STATE OF MAINE
DEPARTMENT OF TRANSPORTATION
16 STATE HOUSE STATION
AUGUSTA, MAINE 04333-0016

January 19, 2023
Subject: Acadia Gateway
State WIN: 017163.03
Location: **Trenton**
Amendment No. 5

Amendment #5 Updates
 -Added 5/A402 to illustrate extent of insulation and foundation wall composition at this location.
 -Keyed this view on key plan

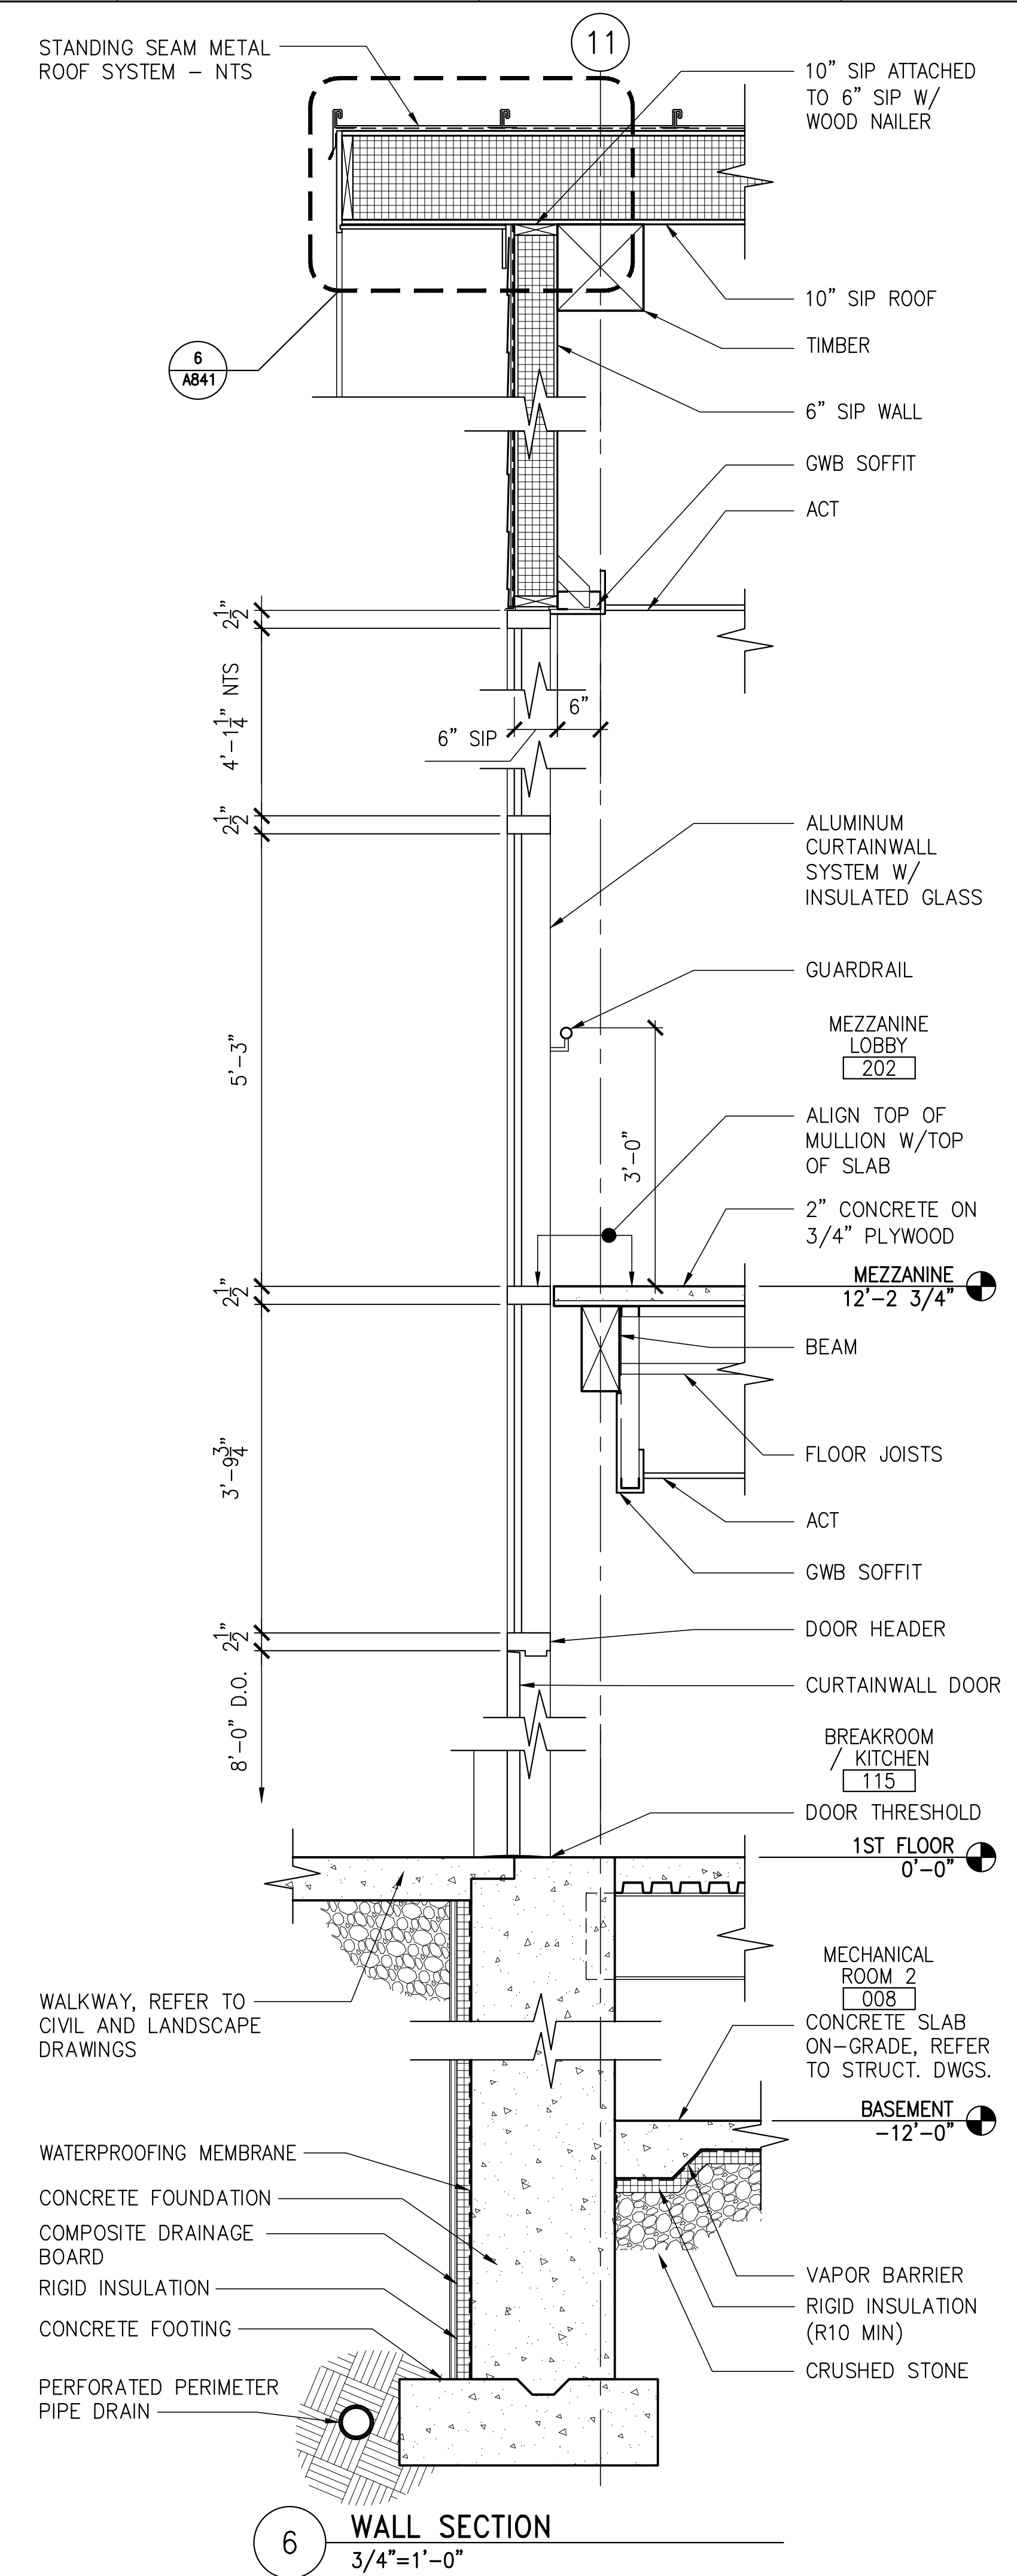
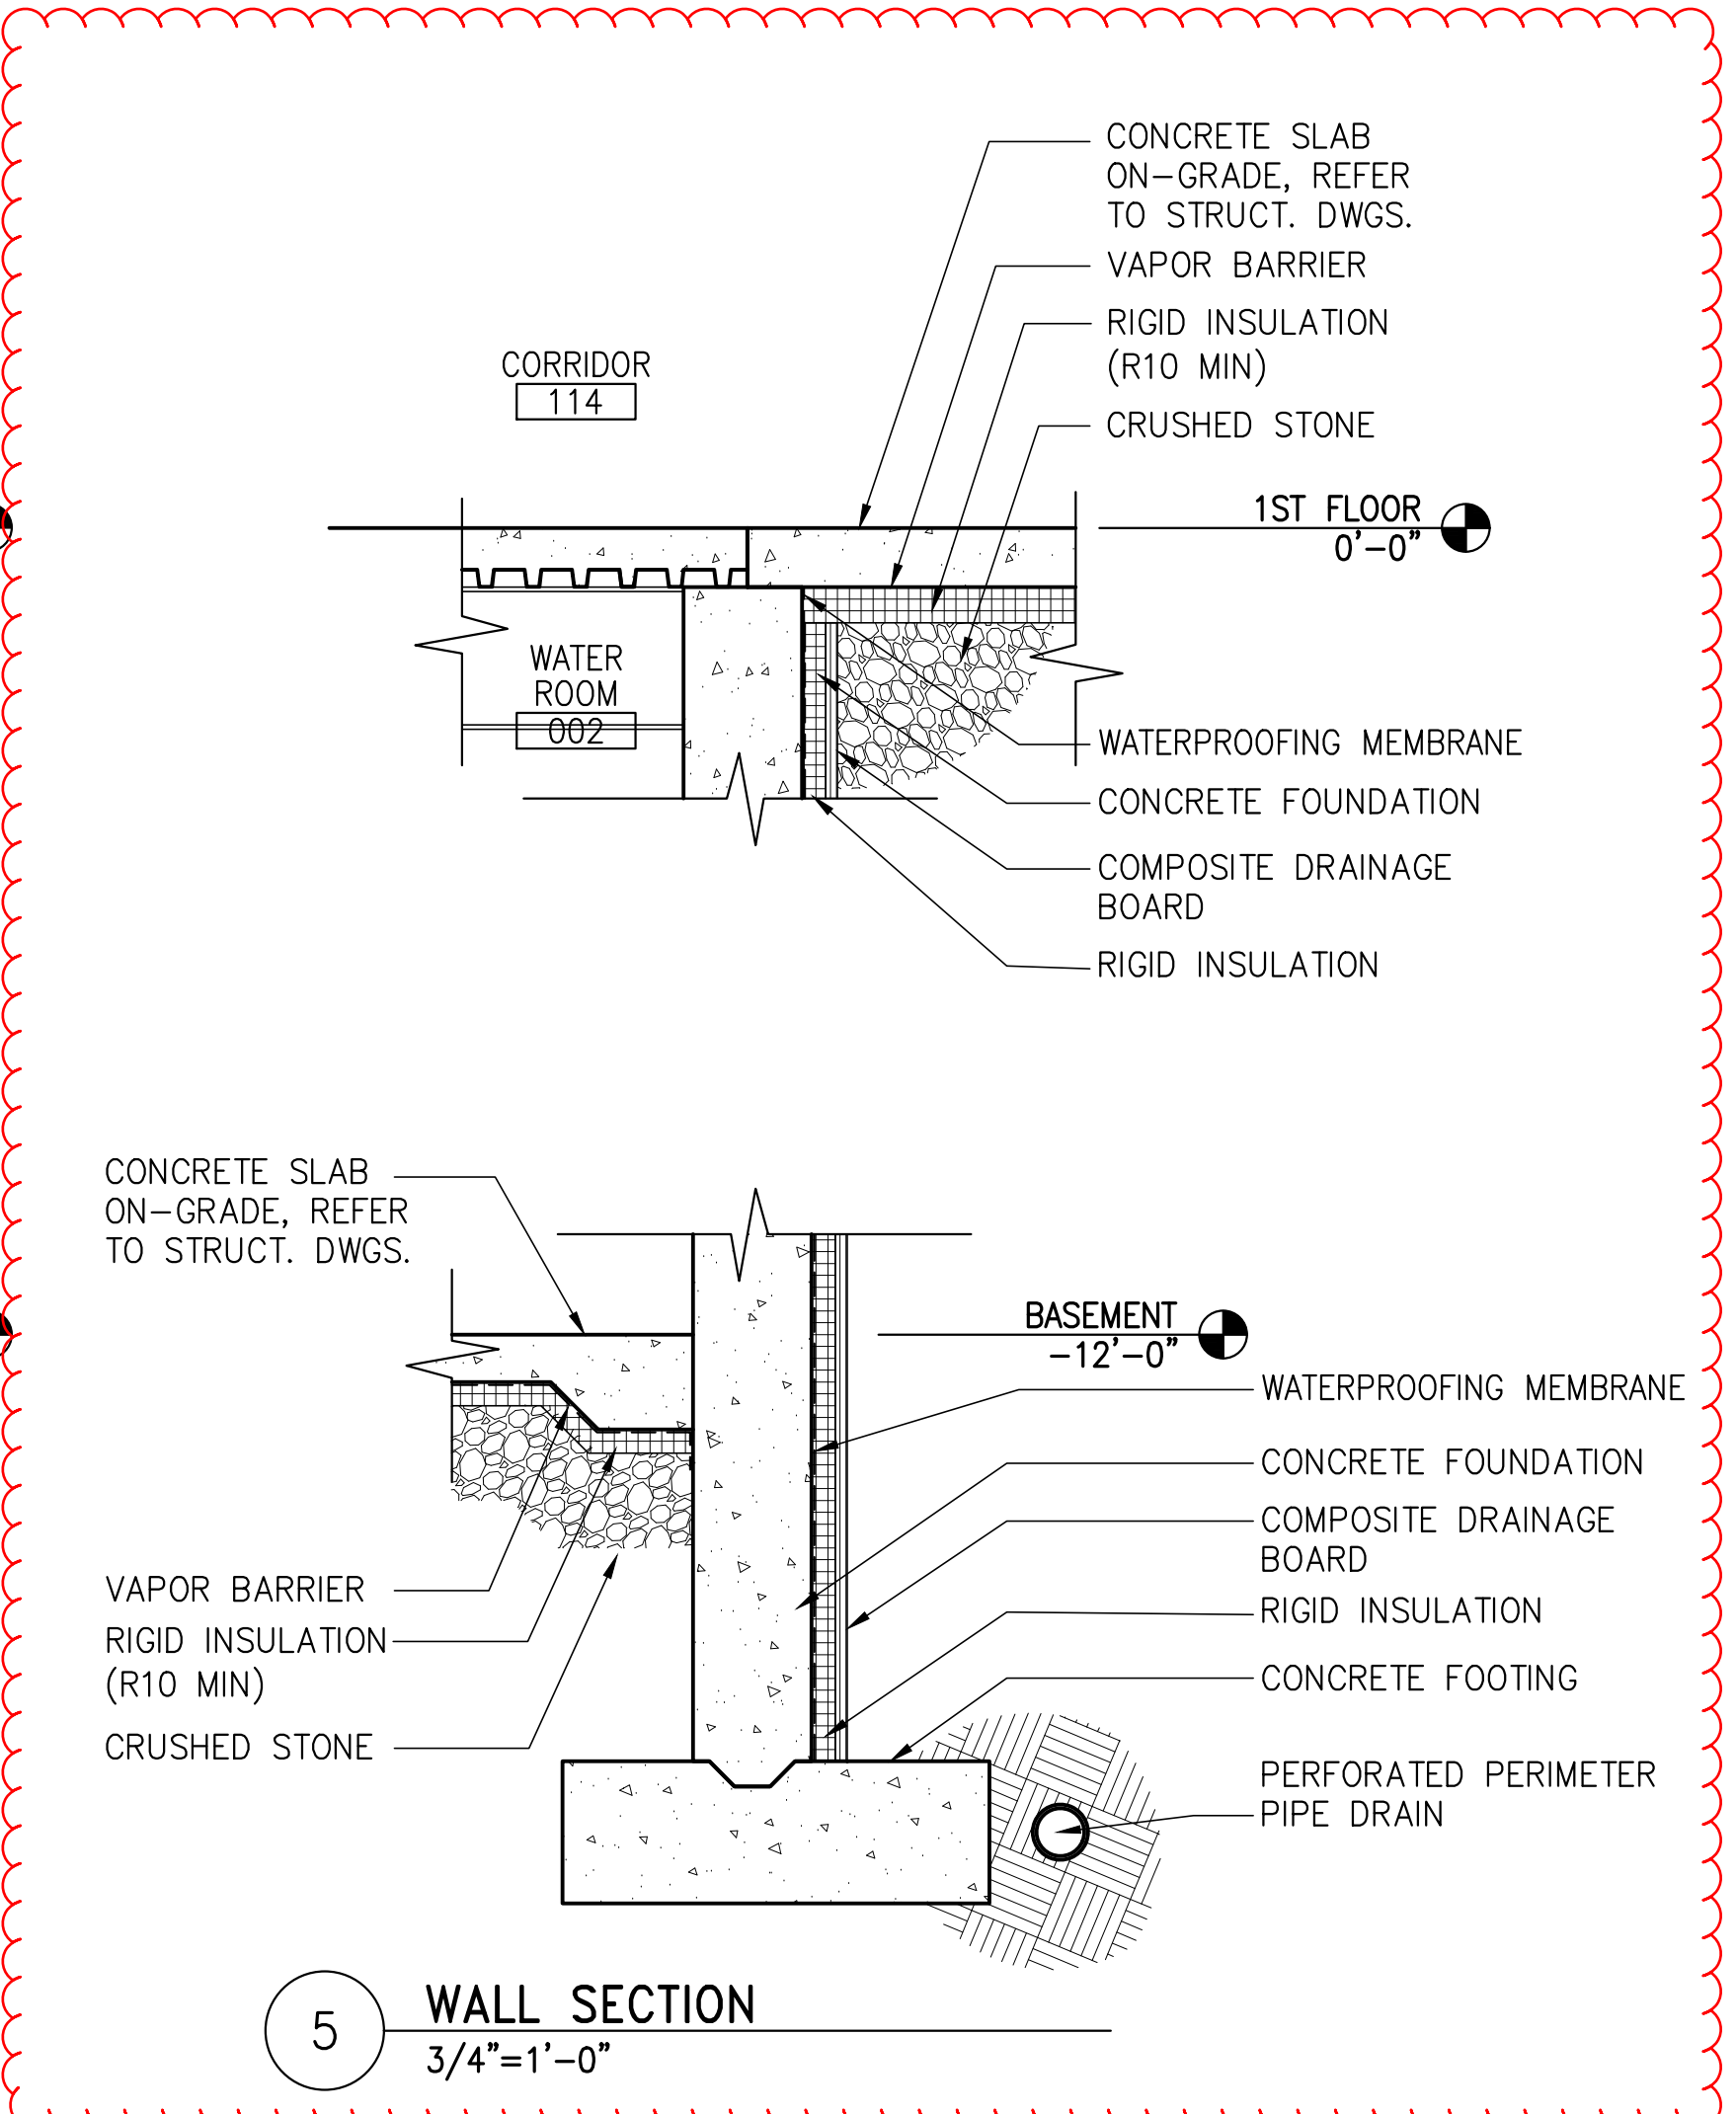
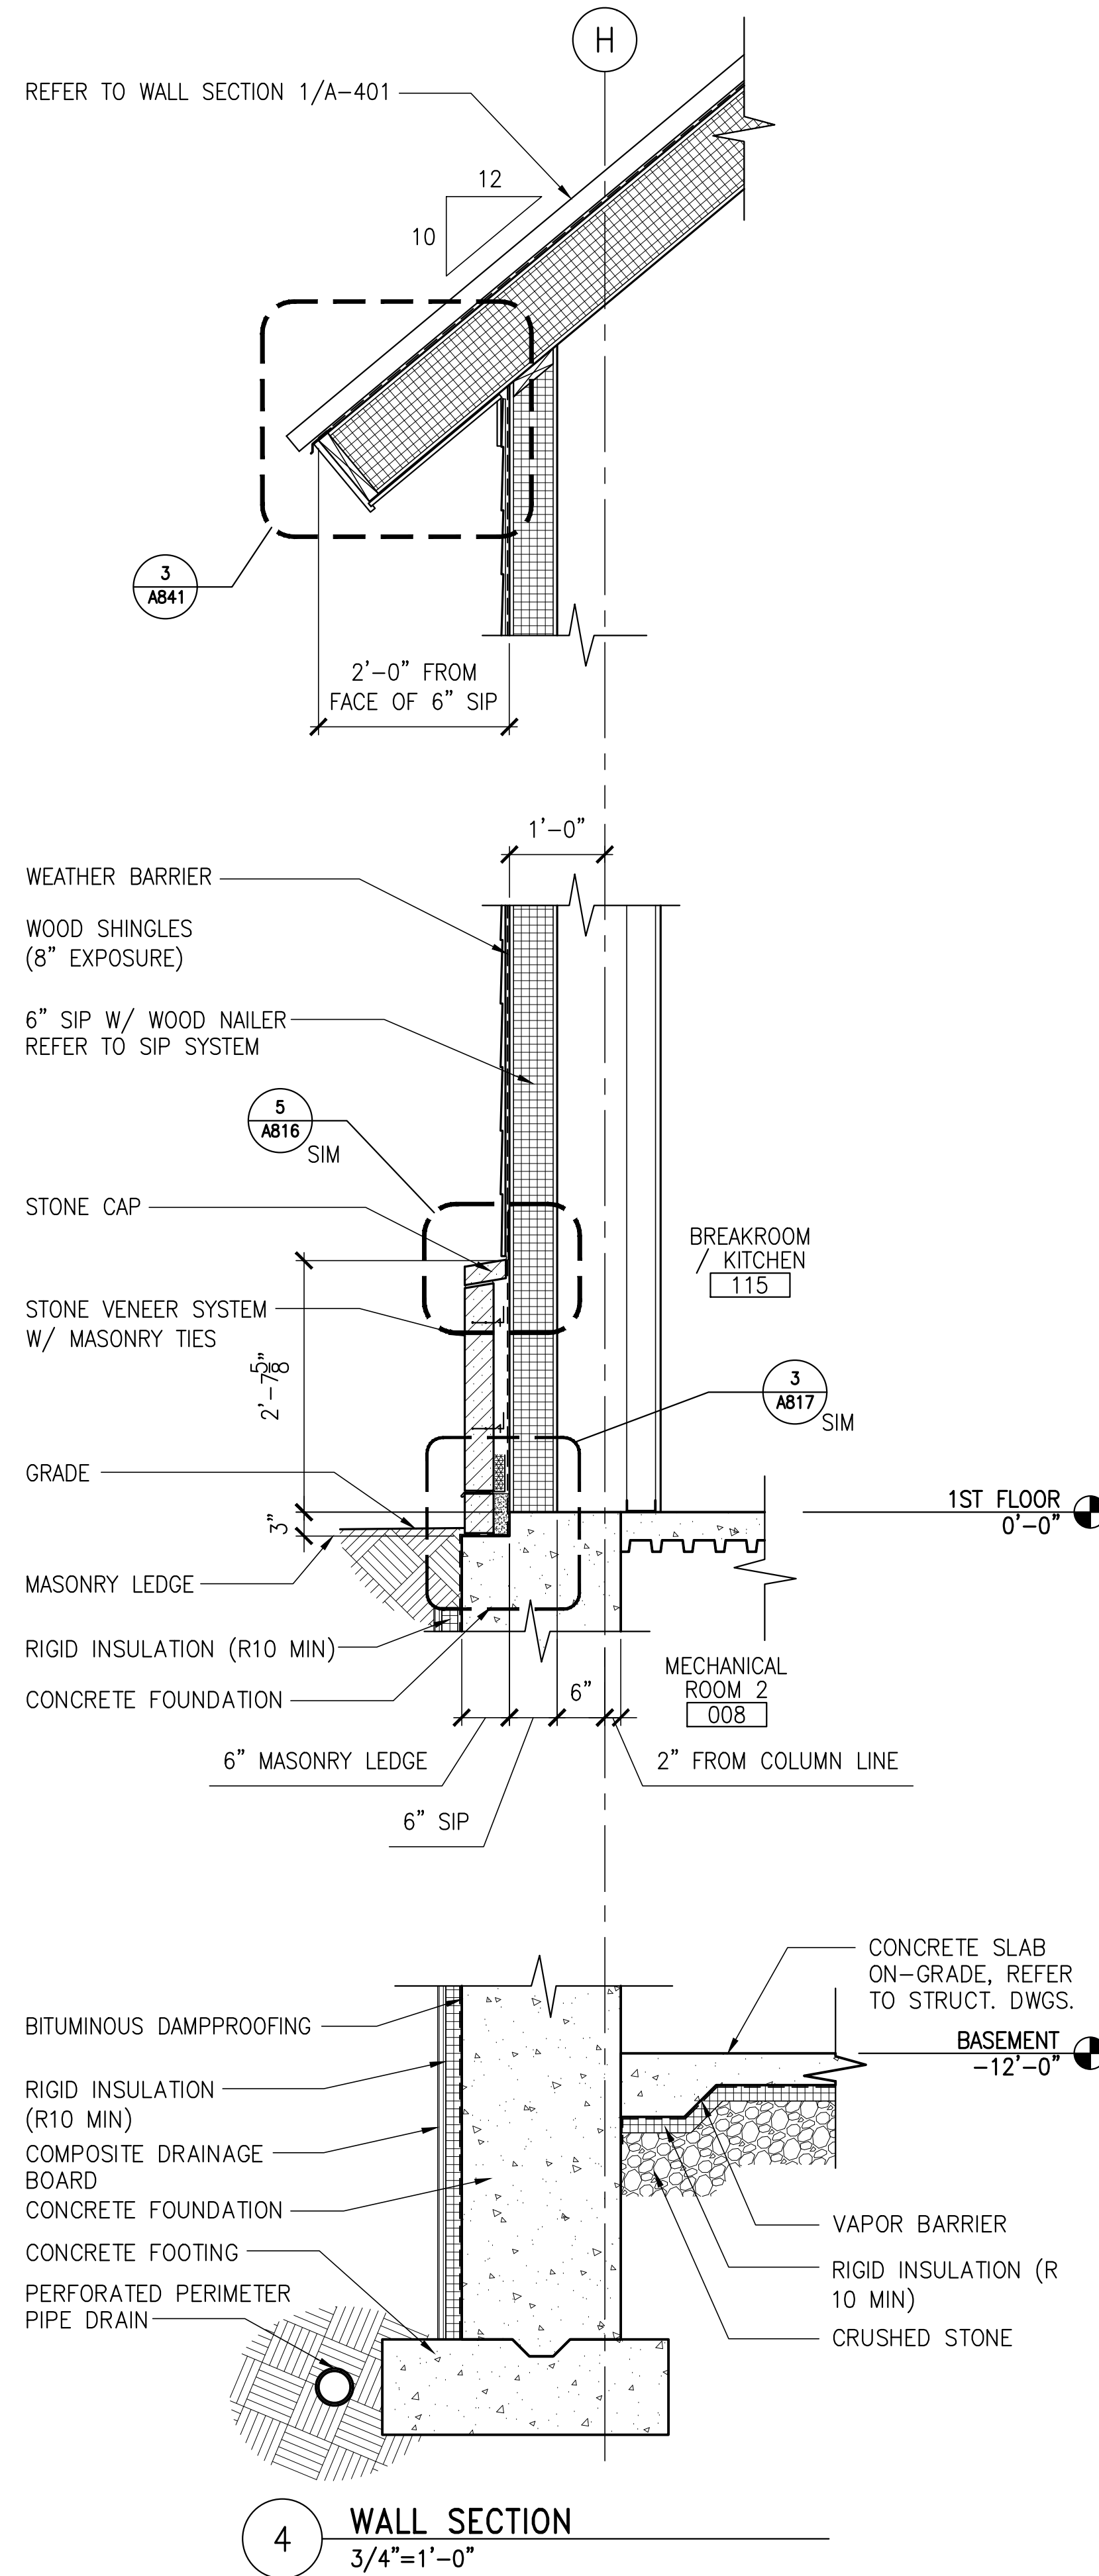
Question: Do basement foundation walls at column line H & 14.5 receive fluid applied waterproofing, molded drainage board, vapor barrier, bituminous damp proofing, or board insulation?

Response: Yes, all basement foundation walls shall receive waterproofing, drainage board, vapor barrier, damp proofing, and insulation. Drawing A401 has been updated in Amendment #5 to reflect this.
